PROPOSED DRAWING CORRECTIONS  
OR APPROVAL BY EXAMINER

S.N. 09/954,821  
Examiner C. Tyler  
Art Unit 3746

FIG. 1

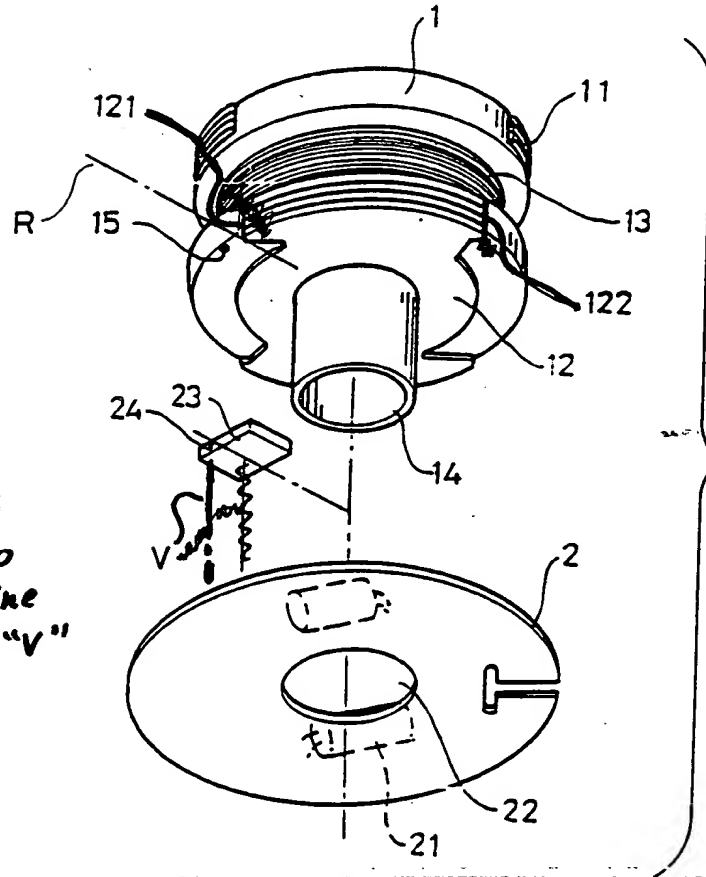
Note to  
Draftsman:  
See Fig. 3  
for details  
on where to  
move lead line  
121 & line "V"
